Access Compliance Report

Public Rights-of-Way

(Curb Ramps)

Intersection ID: 5501	Main Street: BRACHNELL_VIEW_DR	Cross Street: MALLARD_PARK_DR	Location: S
ADA ID: 59F5CA33FDF4	Ramp Type: Perp	Initial Pass/Fail: Fail	Overall Compliance: No
Severity Score: 12.5			
Codes/Mitigation Info/Possible Solution		Field Measurements/Component Compliance

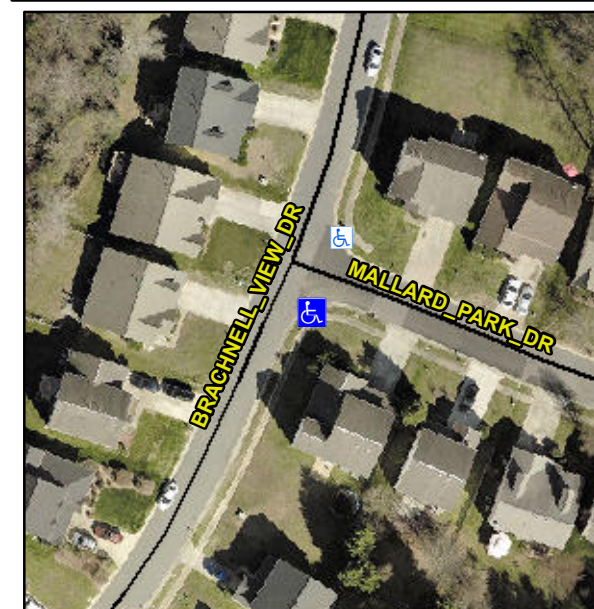
Not Found, R304.2.2

Compliance	Description	Data	Compliance	Description	Data
N/A	Ramp Length (in)	51.0	No	Ramp Slope (%)	8.7
Yes	Ramp Width (in)	50.0	Yes	Ramp XSlope (%)	1.8
N/A	Flare Type LT	N/A	N/A	Flare Type RT	N/A
N/A	Flare Slope LT (%)	N/A	N/A	Flare Slope RT (%)	N/A
N/A	Flare Traversable LT?	N/A	N/A	Flare Traversable RT?	N/A
N/A	Landing Length (in)	N/A	N/A	DWS Provided?	N/A
N/A	Landing Width (in)	N/A	N/A	DWS Contrast?	N/A
N/A	Landing Slope (%)	N/A	N/A	DWS Length (in)	N/A
N/A	Landing X Slope (%)	N/A	N/A	DWS Full Width?	N/A
N/A	Landing Curb? (Y/N)	N/A	N/A	DWS Offset (in)	N/A
N/A	Shared Landing?	N/A			
N/A	Gutter Ponding?	N/A	N/A	Gutter Slope (%)	N/A
N/A	Gutter Lip Ht (in)	N/A	N/A	Gutter X Slope (%)	N/A
N/A	Painted X Walk1?	No	N/A	Painted X Walk2?	N/A
	X Walk 1 Direction	To NE		X Walk 2 Direction	N/A
N/A	X Walk 1 Width (in)	N/A	N/A	X Walk 2 Width (in)	N/A
	X Walk 1 Slope (%)	0.3		X Walk 2 Slope (%)	N/A
	X Walk 1 X Slope (%)	1.6		X Walk 2 X Slope (%)	N/A

Remove & Replace Entire Ramp.
